**Subject: Amendment 02 – Adequacy Review Responses
DRMS Permit No. M-2012-032
Revenue Mine, Ouray County, Colorado**

Ouray Silver Mines, Inc. (OSMI) is submitting responses to the Division of Reclamation, Mining and Safety's (DRMS) adequacy review comments dated February 16, 2022 regarding OSMI's Amendment 02 application. Enclosed with this submittal are the following items.

Amendment 02 Adequacy Review Responses Round 1

REVENUE - VIRGINIUS MINE
Figure : Governor Basin and Yellow Rose
C-1B : Baseline and Current Conditions

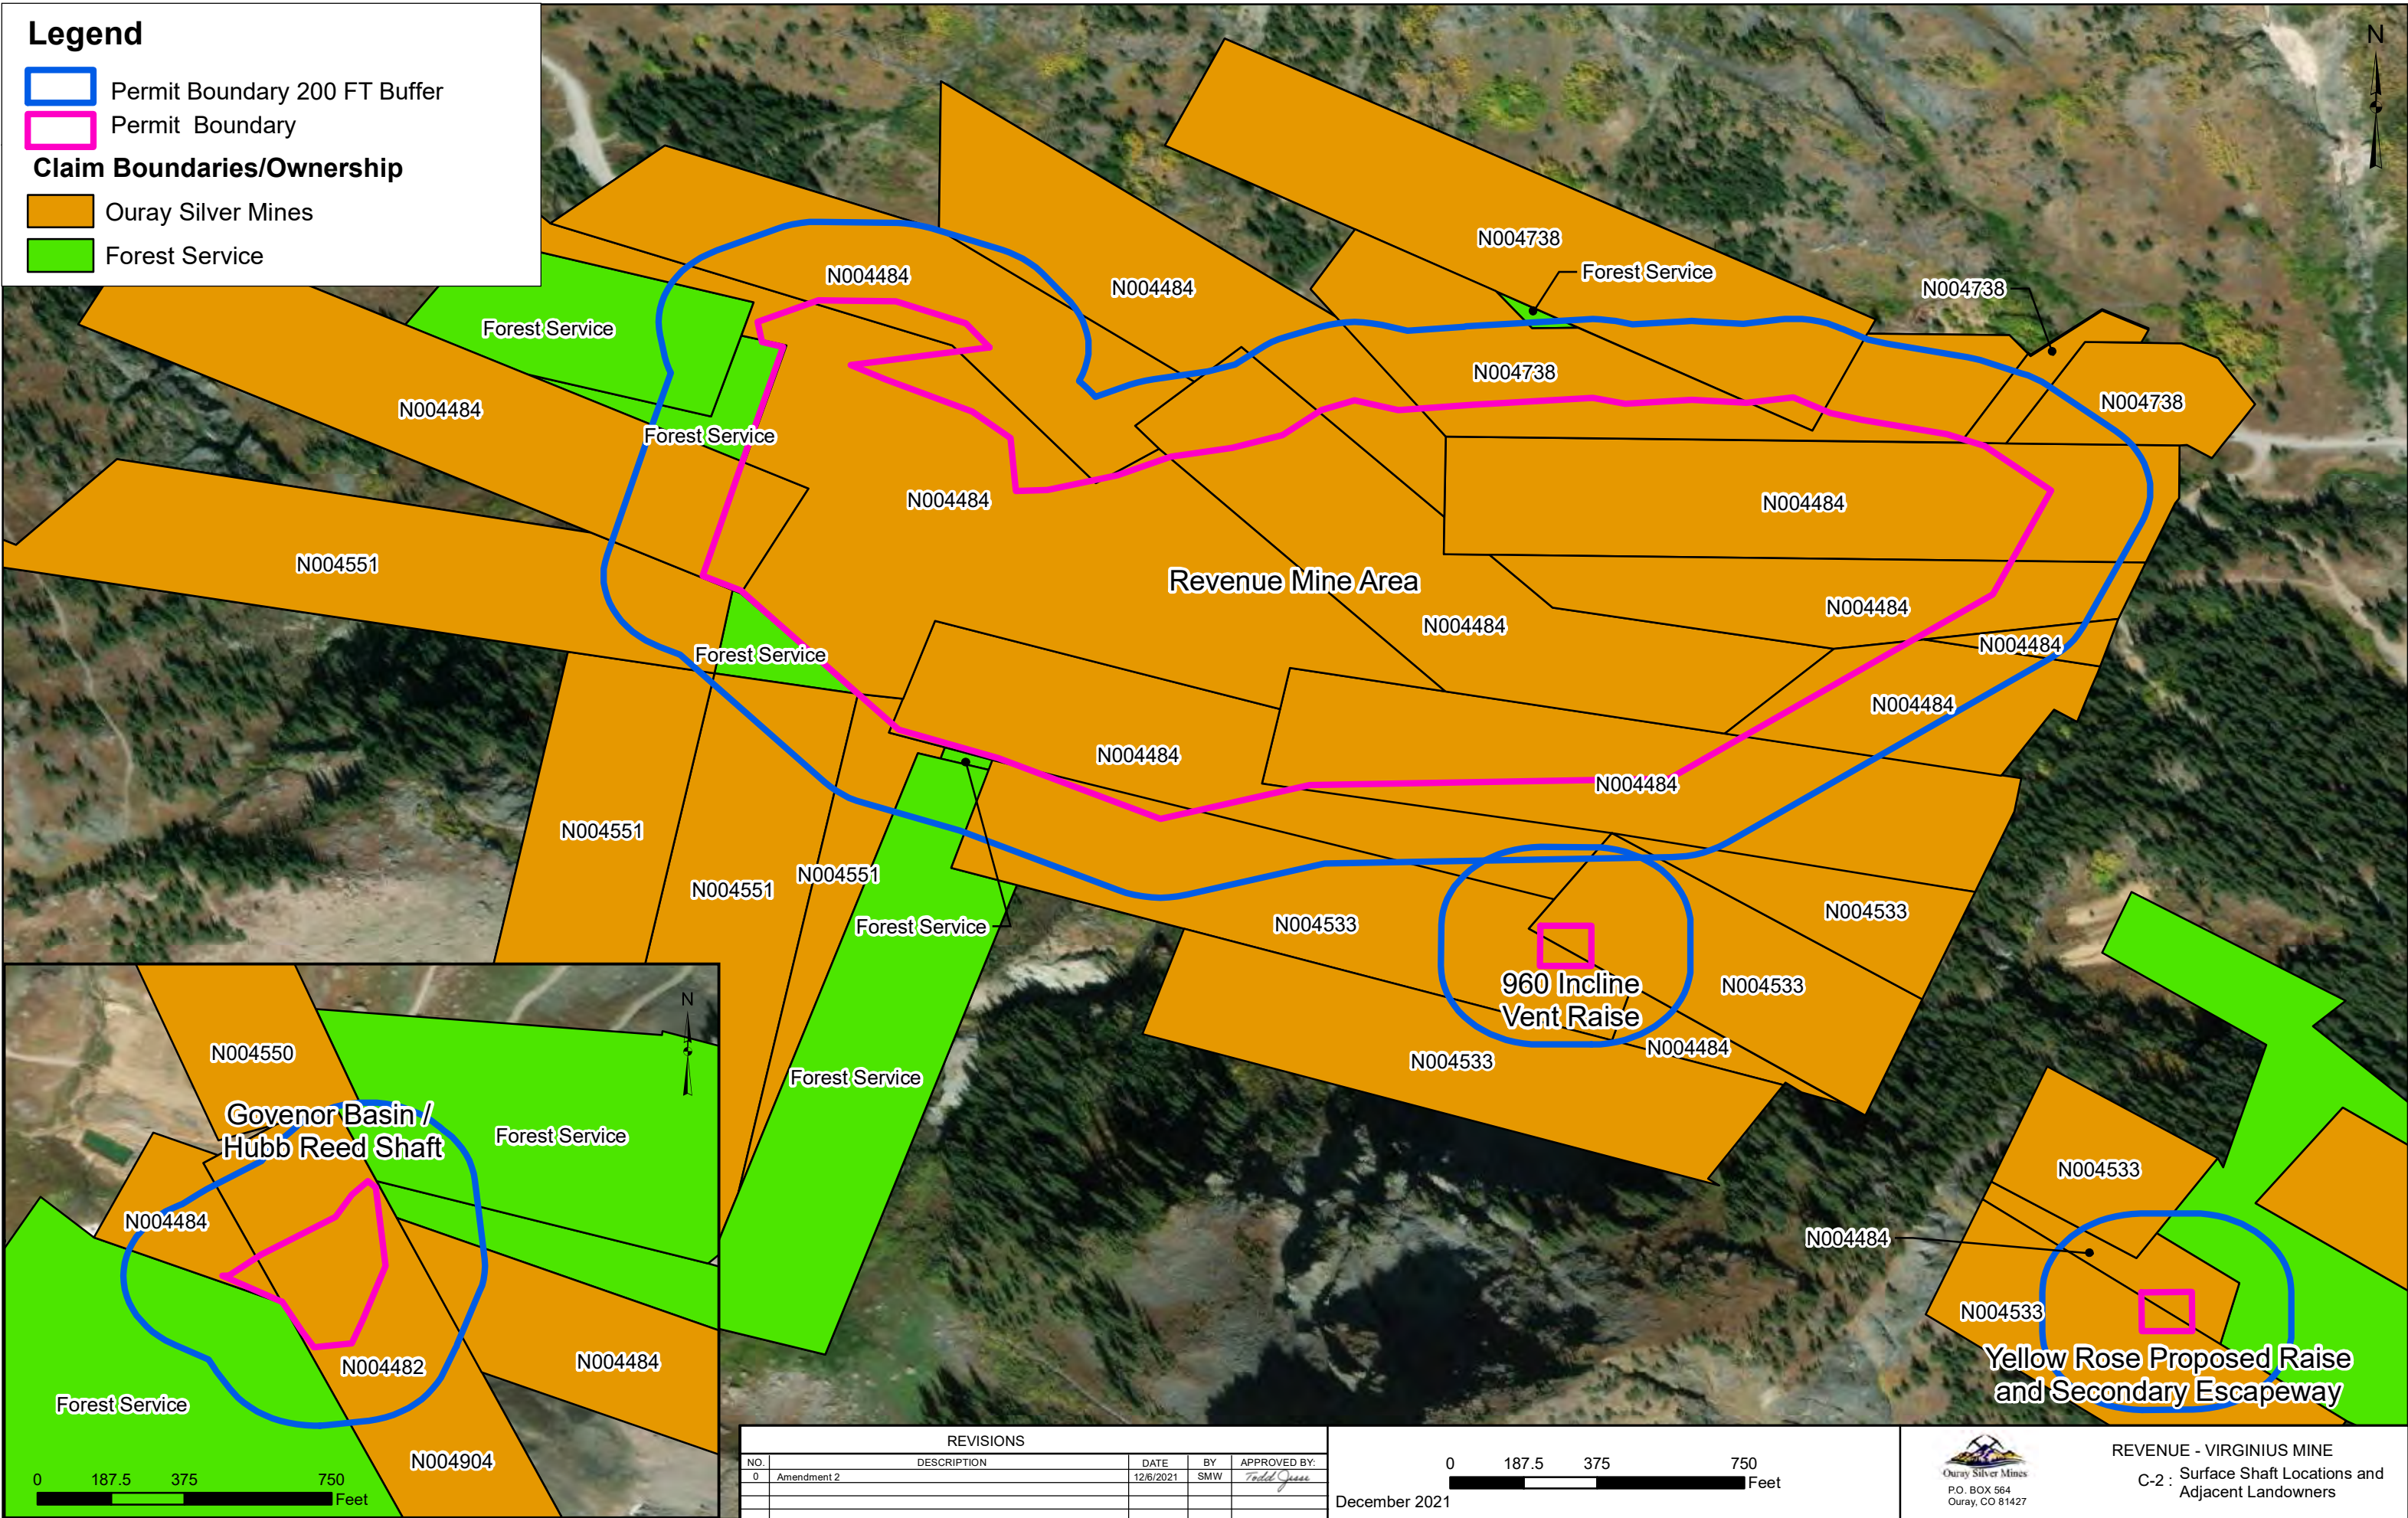
8	No map depicting water information for the 960 Incline or the Yellow Rose was provided pursuant to 6.4.3(f). If desired this information may also be presented in Exhibit G through a revised or new map. See adequacy question(s) under Exhibit G	See map of basins provided in updated Exhibit G. Neither the 960 raise nor the Yellow Rose Raise have been developed. Currently there is no water feature associated with either of these raises. There may be a small amount of meteoric water that enters the raise once constructed but that is expected to be minimal and will not impact the overall water balance for the mine. In addition, OSMI has no plans to ever construct the 960 Raise and will be seeking an acreage reduction request for that area following approval of Amendment 02.
9	No map was included in Exhibit C or S that depicts the owner's name, type of structures, and location of all structures contained in the area of affected land and within two hundred (200) feet of the affected land, pursuant to 6.4.3(g). Please submit a separate structure map, depicting the required information of this section. Please note that also in Exhibit S, the informational sign located North of Pond 2 is not identified; be sure to include this in the revised map and appropriate Exhibits.	Exhibit S provides a table of all permanent manmade structures within the permit boundary and within 200 feet of the permit boundary. Exhibit S cross references the structures, which are labeled on Exhibits C-1a and C-1b. The owners name and type of structure have been added to Map C-1a and C-1b. All structures located on the mine site and within 200 feet of the permit boundary are located on OSMI property and owned by OSMI with the exception of County Road 26, the powerlines and the restroom structure. The interpretive sign is owned by OSMI and was added to the Exhibit S table and Exhibit C-1a. Structure agreements from the FS and Six Basins are provided in Updated Exhibit S.

REVENUE - VIRGINIUS MINE
Map F-1 : Reclamation Plan

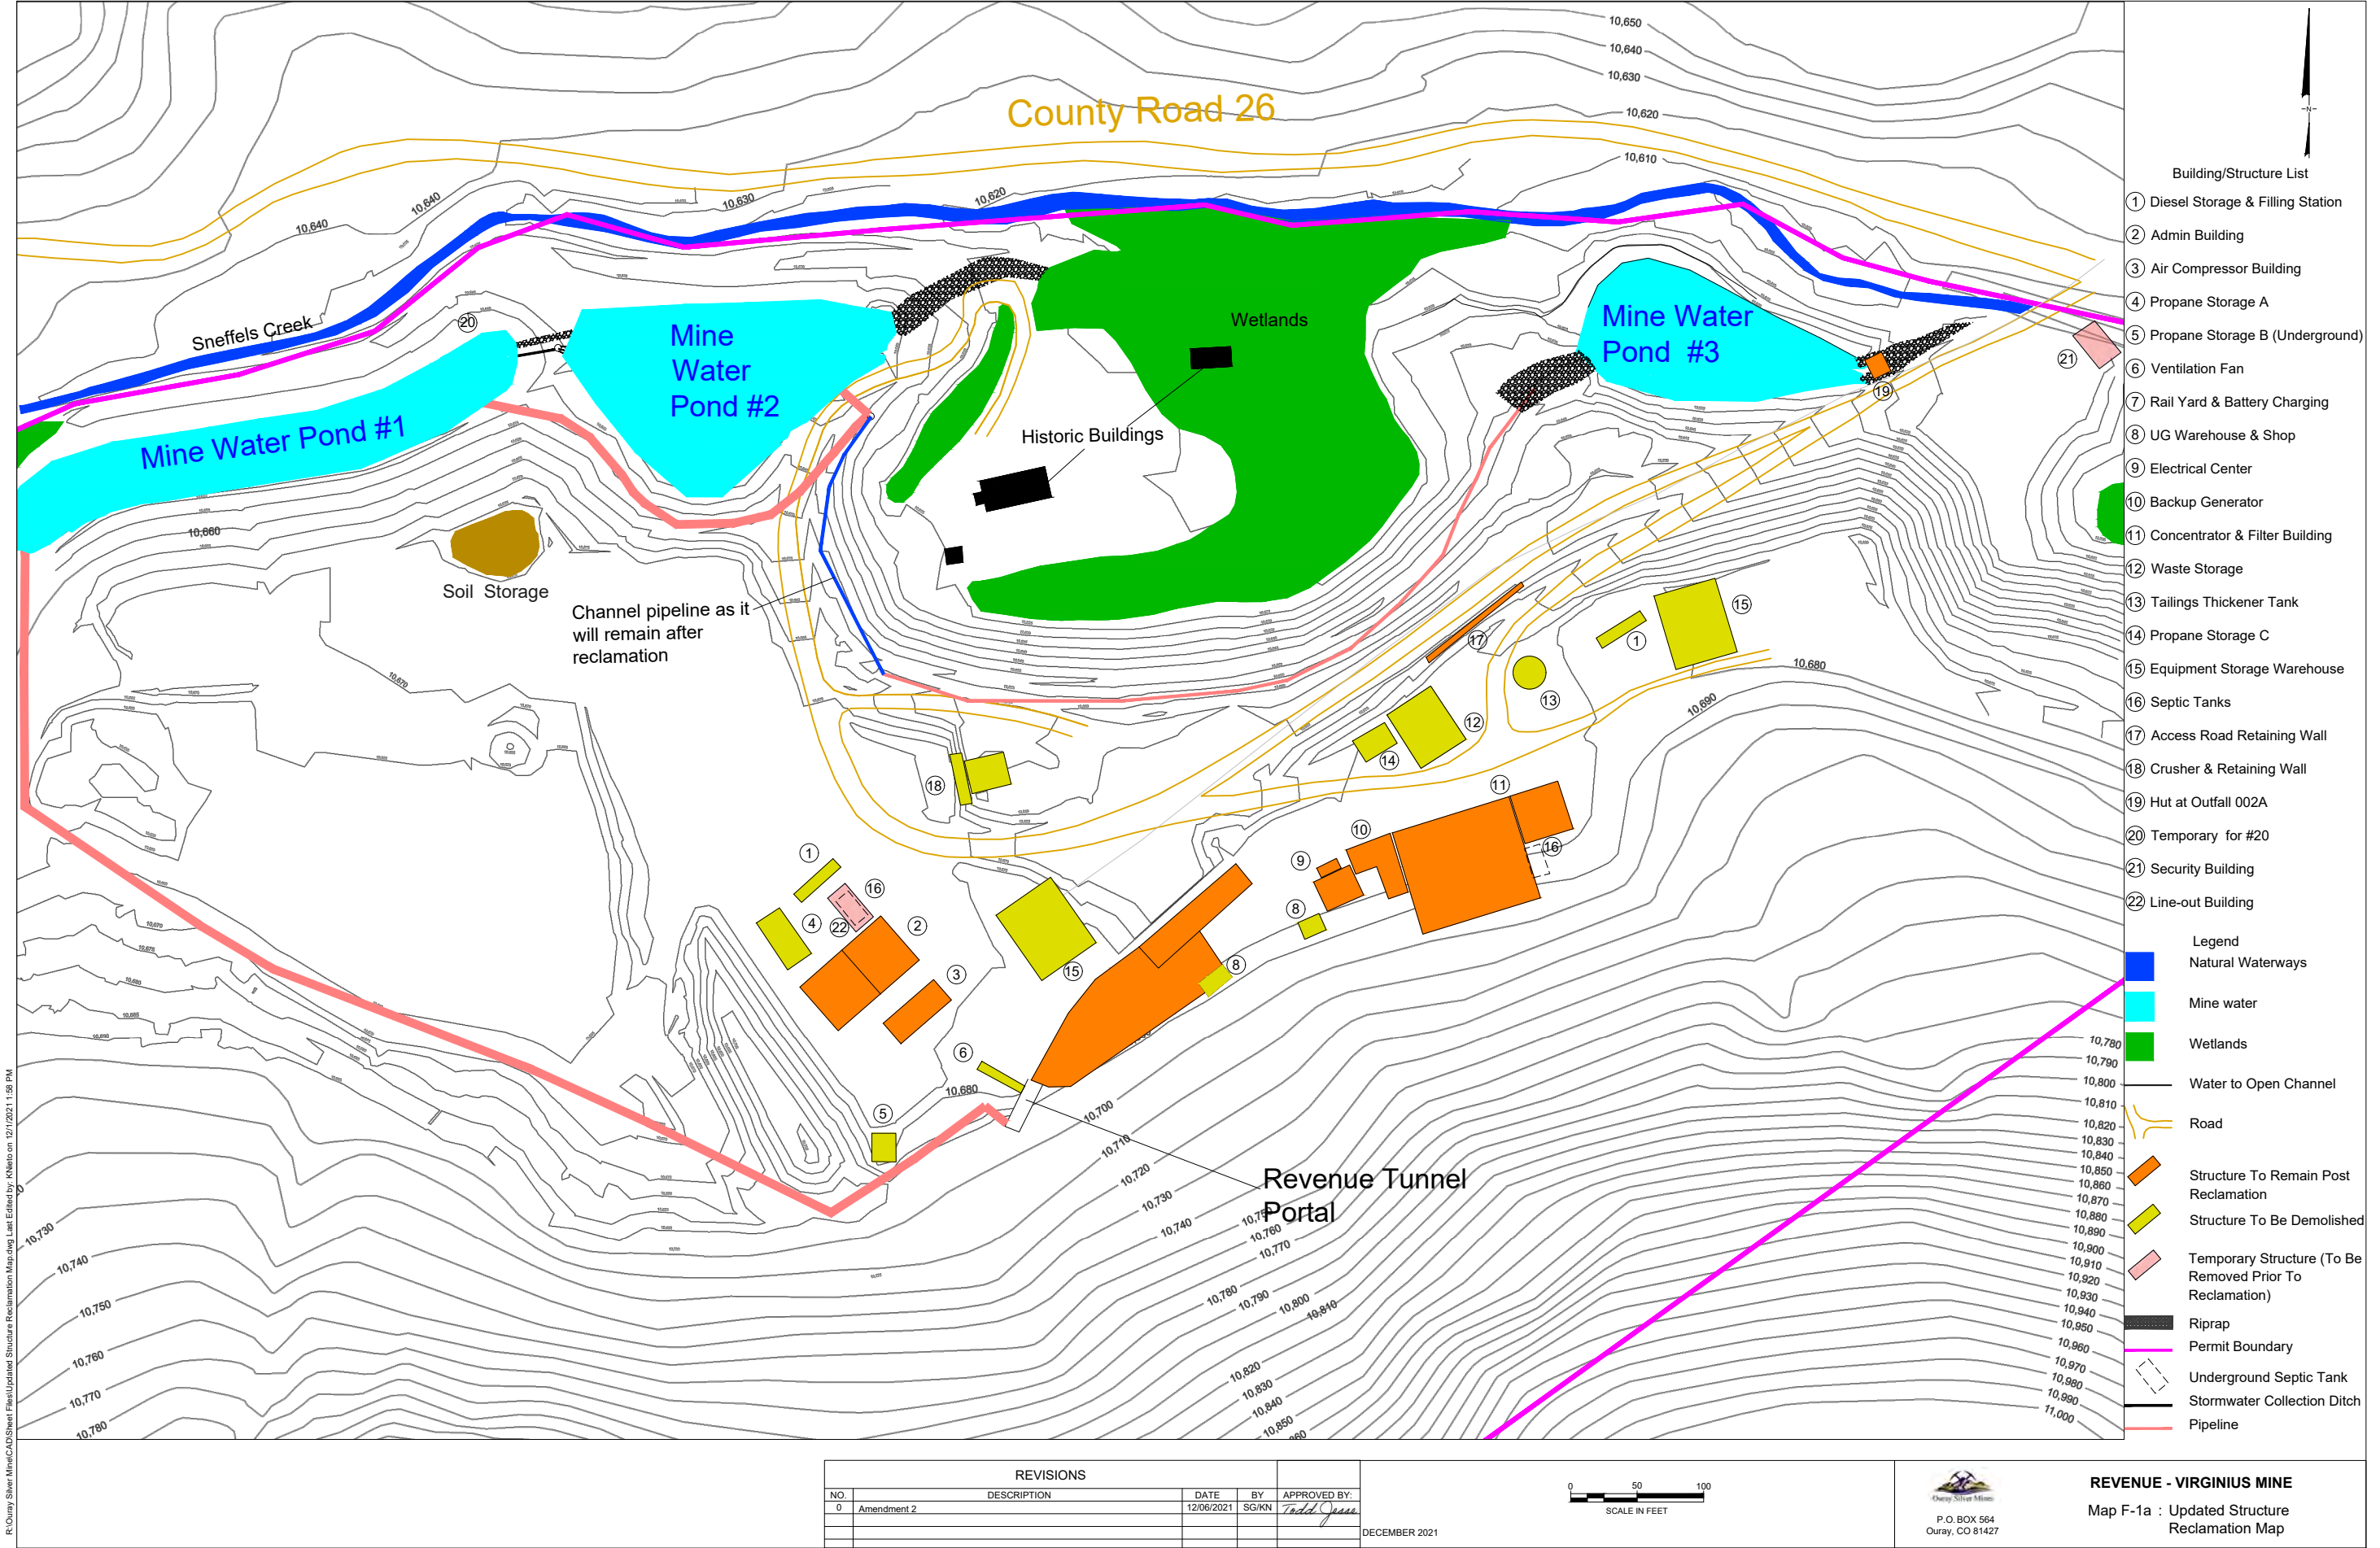
46	Explain in more detail the table provided on map F-1 regarding the TSF. The table suggests that 6.1 Acres of the Revenue TSF and 3.6 Acres of the Atlas TSF will have exposed tailings however, the map shows areas not to receive revegetation will be capped with waste rock which is consistent with the narrative (2015 TWRMP). The table appears to not match the shaded areas depicted in Map F-1 please clarify the table regarding applicable acreages of the reclamation. Please revise the included table to accurately demonstrate the reclamation measures in the narrative.	Per the updates provided in Section 3.1, the area on the TSFs that will not receive topsoil will be capped with San Juan Tuff to blend in with the surrounding landscape. Map F-1 has been updated to better reflect the different types of reclamation.
47	Map F-1 explicitly states that "All regraded slopes will be no steeper than 3H: 1V." This is inconsistent with discussions in the Mining and Reclamation Plans, please see adequacy items in Exhibits D, E, and 6.5.	The footnote on Map F-1 has been deleted.

48	Map F-1 appears to depict the bridge and an access road at the Atlas TSF leading to the sediment pond. This feature is depicted as both covered in waste rock and remaining as dirt. Please clarify if these are post reclamation features. If they are to be reclaimed please provide details in the reclamation narrative regarding the reclamation of the bridge, sediment pond and access road as well as update on applicable maps.	The road and bridge will remain post-reclamation. The bridge and road are constructed out of crushed waste rock used as road base. Map F-1 has been updated to remove the shading on the access road, which is included in Updated Exhibit F.
49	If certain figures are to be removed upon final reclamation they should not be depicted on the final reclamation plan map (Map F-1). Map F-1a adequately demonstrated which structures stay or will be removed. Map F-1 should depict the site as will be upon completion of final reclamation.	Comment noted. Reclamation Map F-1 has been updated to show final configuration post reclamation and buildings and other features that will not remain have been removed from the drawing.

Figure K-3. Annual Evaporation Data (in inches) for Revenue Mine Area (data taken from NOAA's Report NWS33, Colorado Annual Evaporation Chart)

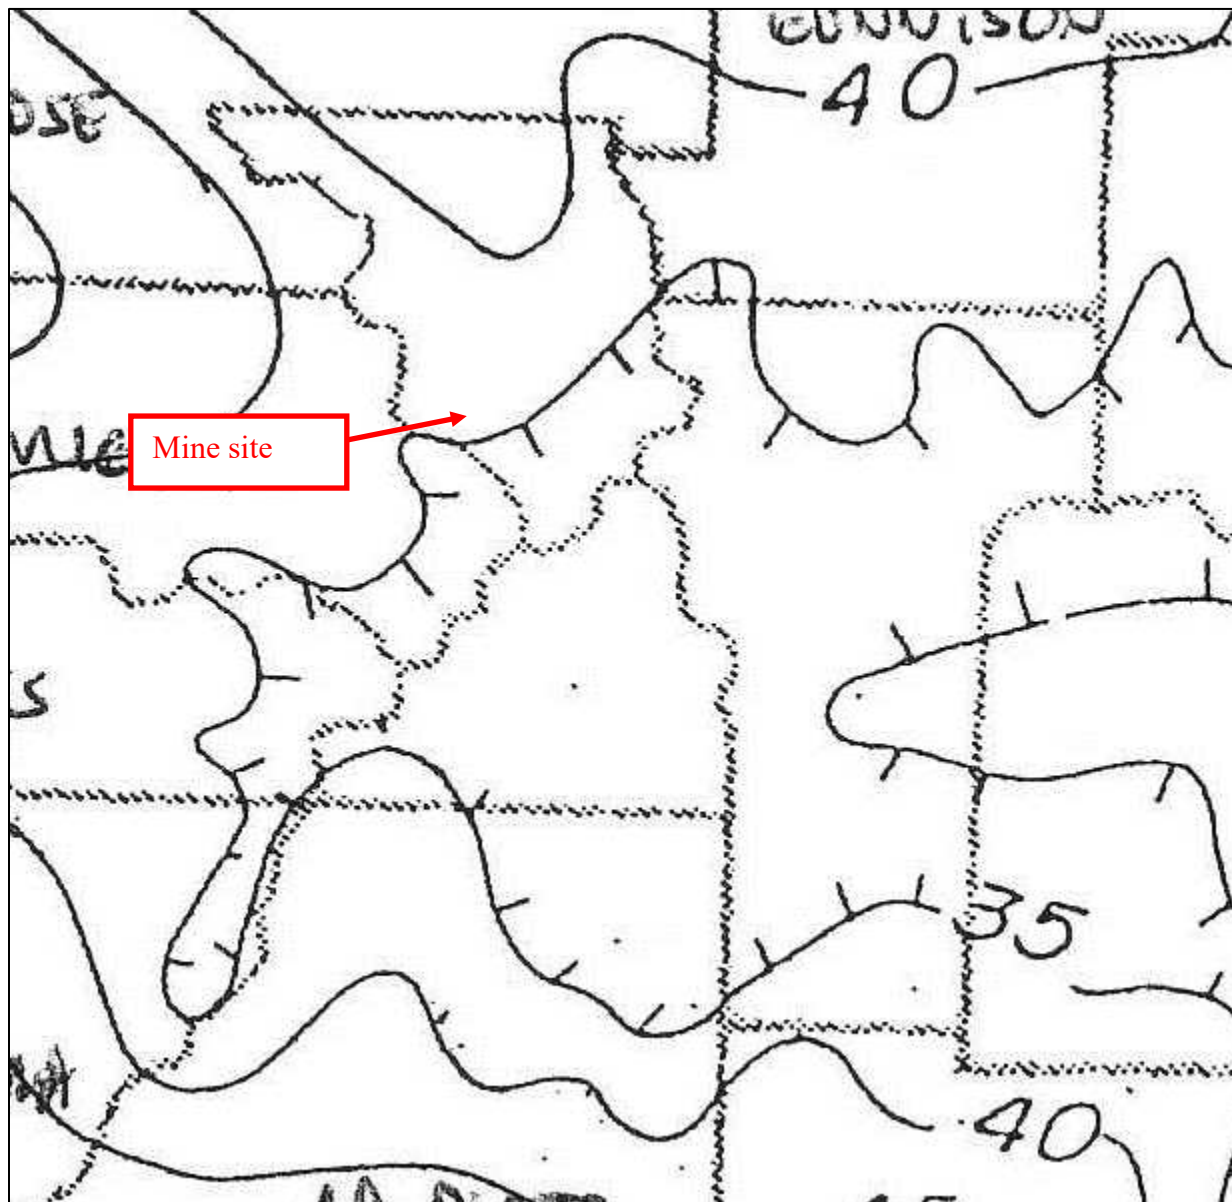
109	Based on the information provided in Exhibit K the Division cannot perform a 'water balance' for the site as required by Rule 6.4.21(13)(a). Figure K-3 lacks reference units to compare against precipitation data provided in Table K-2. Additionally the Division is uncertain as to the time scale either of these figures occur over.	Section 12 of Exhibit U was updated to include specific weather data going back 5 years as well as average wind speeds and direction.
